APPENDIX G

WRITTEN COMMENTS ON THE DSEIS

Re: Draft Supplemental Environmental Impact Statement for Fresh Kills
East park Roads – **CEQR#: 06DPR002R**

FIGURE 1

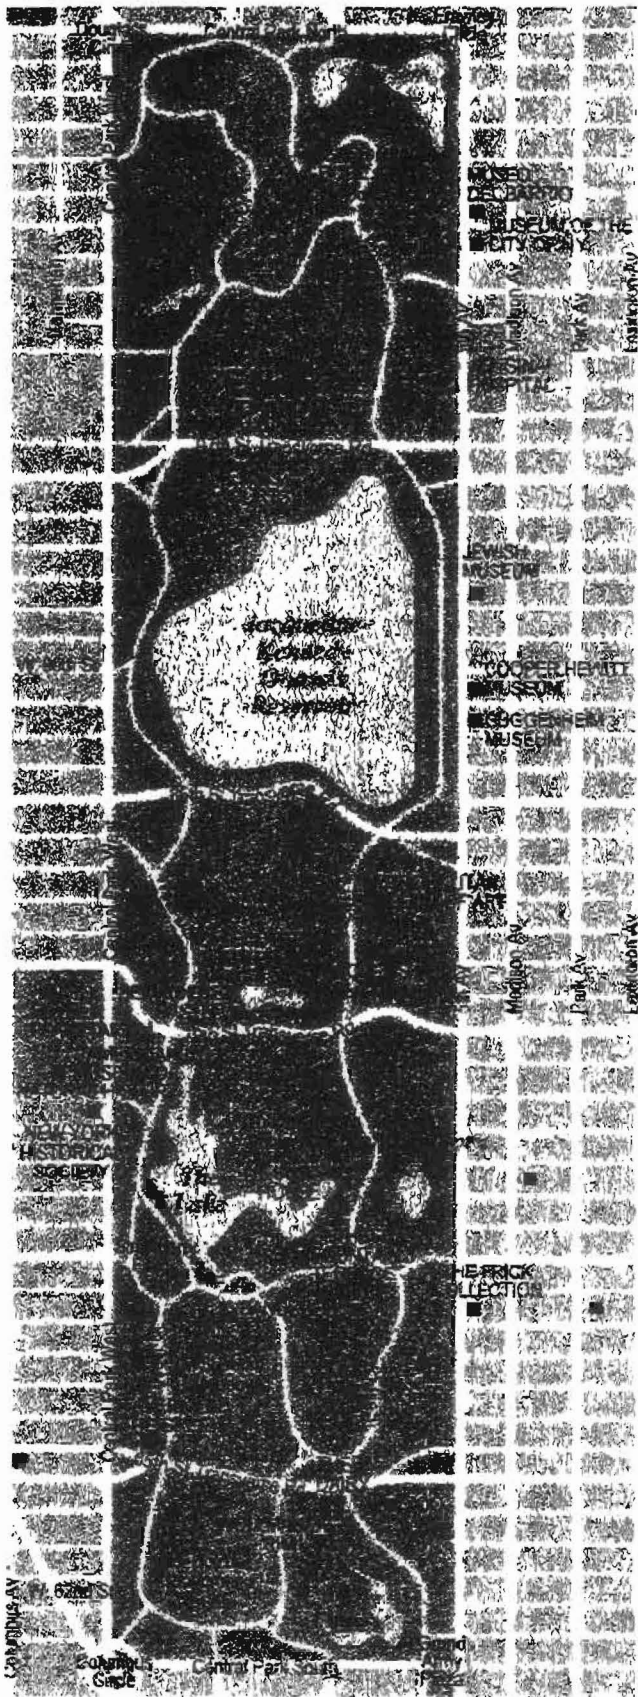
Examine the four figurers that I have attached to this letter. The first figure shows Central Park and all the roads that traverse through it, moving traffic east and west, north and south, and literally all around it. What is amazing is that this 843 acre park has so many roads that

effectively shifts traffic through a large number of ingresses and egresses. Can you imagine what the surrounding areas, and probably a majority of Manhattan, would be like, traffic-wise, if you eliminated more than 90% of these connections and passageways?

FIGURE 4

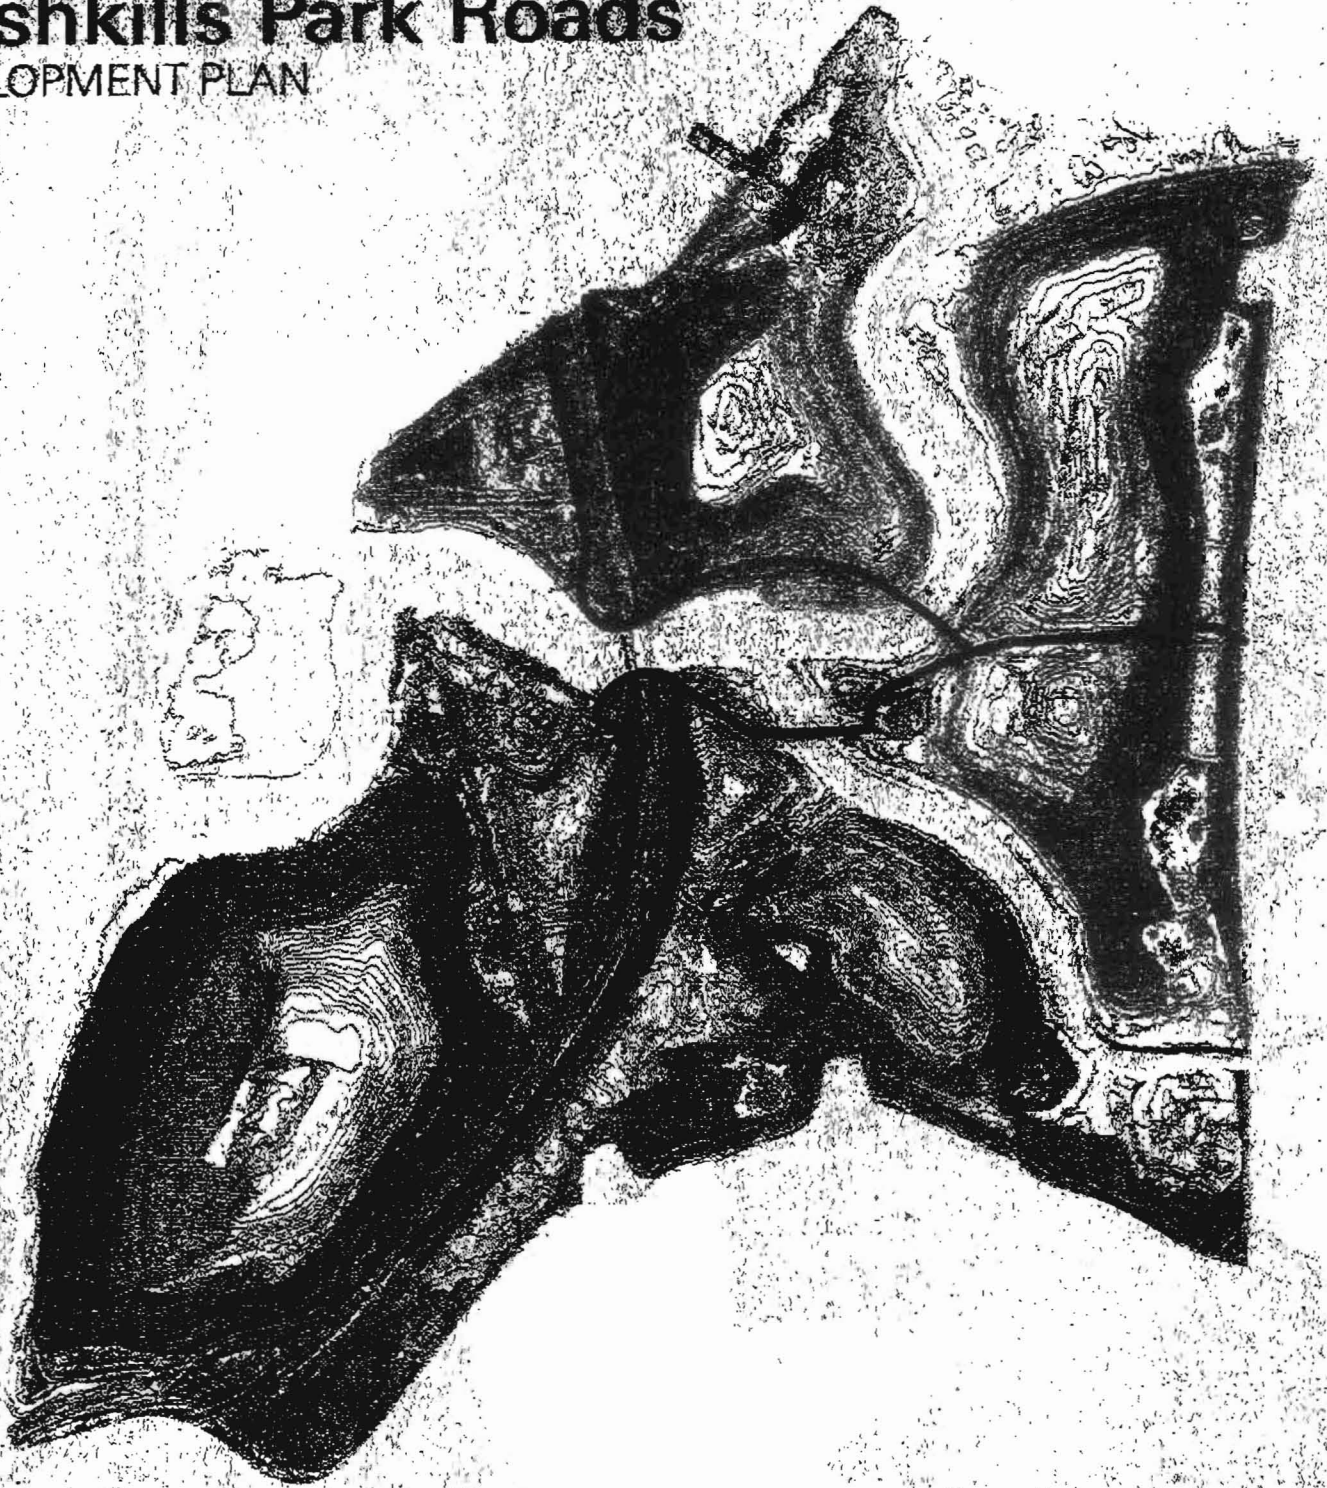
Instead, what I fear will happen is that, as shown in Figure 4, by the year 2016, all that Staten Island can possibly expect is one through road, with no definite word on any other connection for almost another 20+ years.

So I have to ask: why is it that Manhattan and Brooklyn can have a park with many through roads for their traffic congestions while Fresh Kills, 3-1/2 times the size of Central Park and 5 times the size of Prospect Park, gets one through road in seven years – and nothing else in the next foreseeable generation?
